PCN: V19-002-48475413-0A

# **Product Change Notice**

Product Moisture Sensitivity Level (MSL) reclassification for ChipLED part numbers listed below.

HSMF-C116 HSMF-P11A HSMF-C127

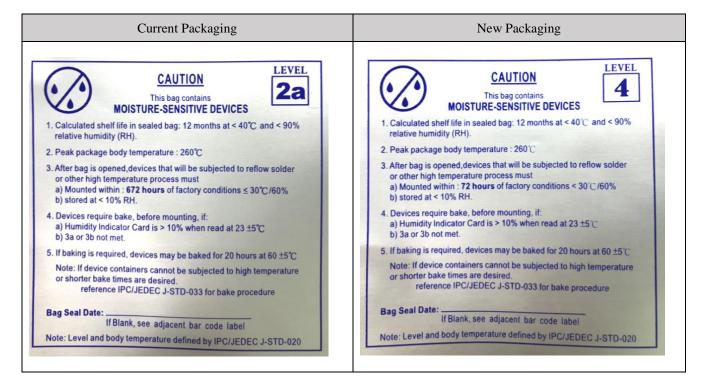
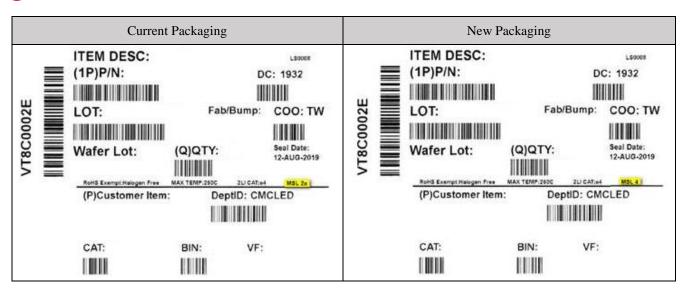
Encapsulant material change.

Product with new encapsulant material will be reclassified as MSL 4.

The encapsulant material production was obsoleted.

There is no change in fit, form and function. Changes in product handling will be reflected in its packaging and new datasheet.

Shipment will contain parts with new MSL rating starting 20<sup>th</sup> March 2020.
